ORDINANCE 94-18

TO AMEND THE BLOOMINGTON ZONING MAPS FROM SI to RL,
GRANT PUD DESIGNATION, AND APPROVE OUTLINE PLAN
Re: 1730 N. Range Road
(Regency Associates, Petitioner)

Case No:RL/PUD-15-94

PRELIMINARY STAFF REPORT

Site Plan
 RL/PUD - 15-94

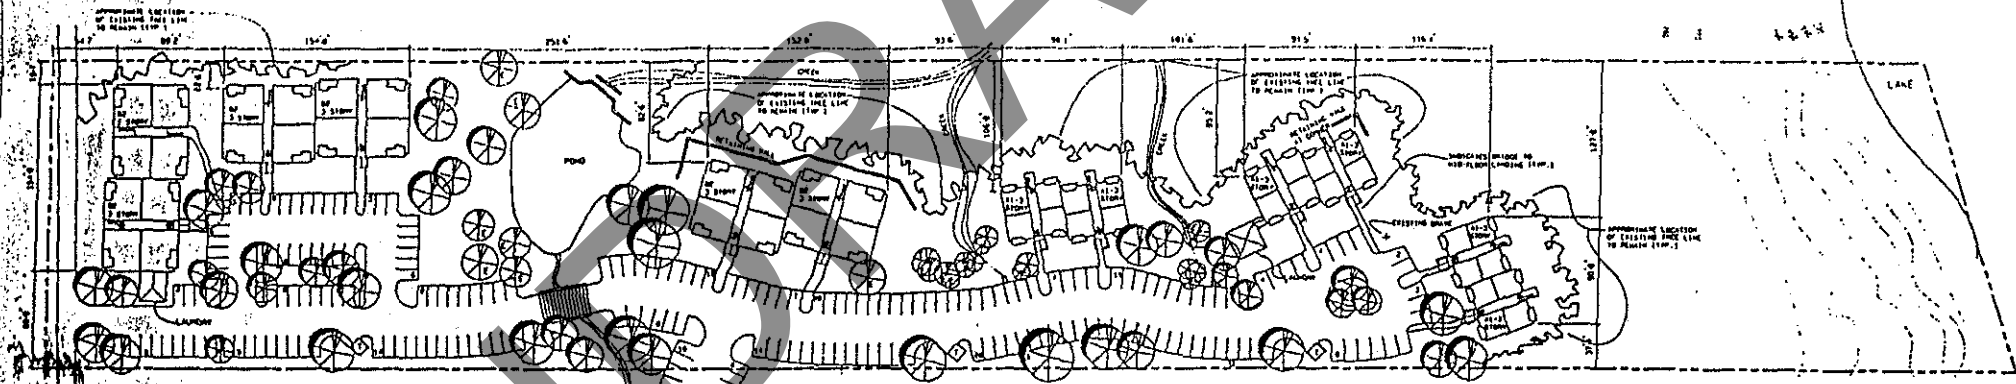
5. The density issue is a difficult one because the high density use to the south conflicts with this property's location in a heavily vegetated site in the Lake Griffy Watershed. The Environmental Commission, however, is advocating the deletion of structure number 3 from the proposed site plan. This would reduce the development's density to 12 units/acre rather than 14.4 but still put it within the Master Plan's range of 12-15 units/acre for high density residential housing. The location of structure number 3 is entirely vegetated and framed by two ravines. The underlying slope is steepest of any of the structures (approximately 15-16 percent). It requires more parking than the structures located further to the east (48 spaces as opposed to 24). We urge that the Plan Commission consider the positive environmental impacts of reduced impervious area and the maintenance of existing terrain in evaluating the density issue.

4. Density of development is always an issue for properties in lake watershed areas. The existing topography and forest cover dictate a lower density of land use. Contiguous development to the south would support more intense land usage. In order to better protect natural features and insure the long-term quality of the watershed, the Environmental Commission would support a loss of one structure on the site. This would reduce the structures to 5 and the number of total units to 120 (12 units per acre).

Sediment Control Pond
 RL/PUD-15-94 38

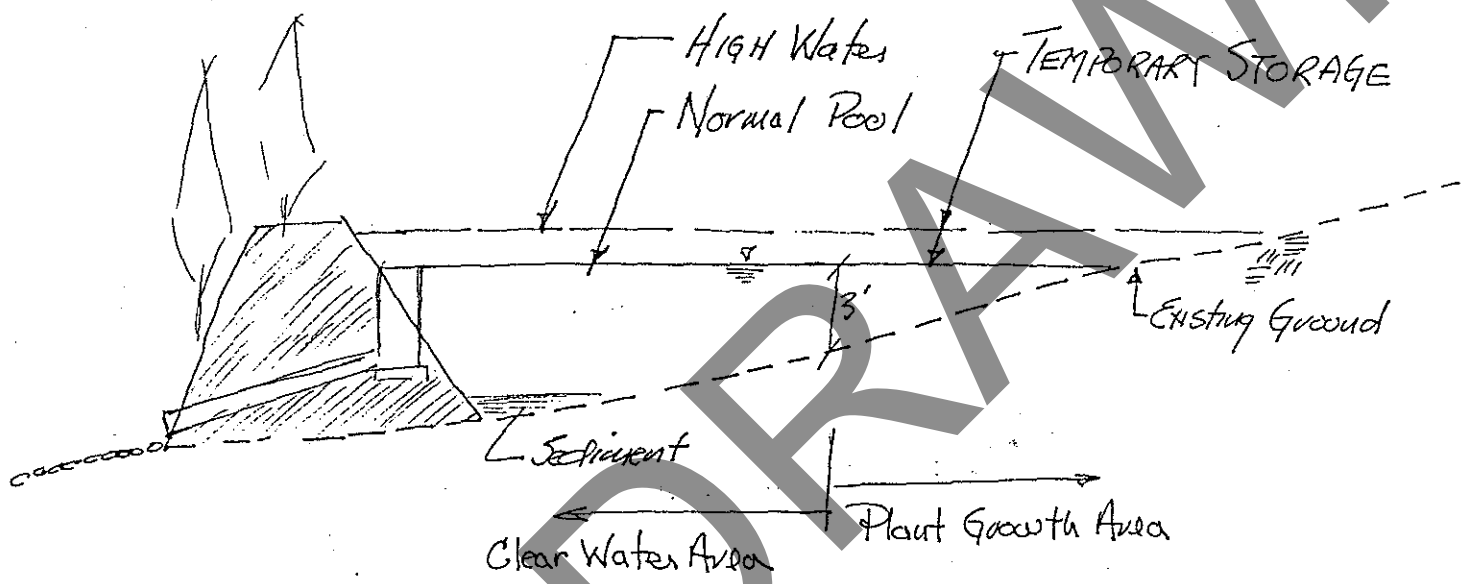
The petitioner has included a cross section of the sediment control pond which would be vegetated from a depth of 3' to the perimeter of the pond. This pond would retain sediment from both the parking areas in the existing Fountain Park site and the new ten acre development. The design would channel run-off via a storm sewer system to a single detention area. The detention area will feature vegetative filters.
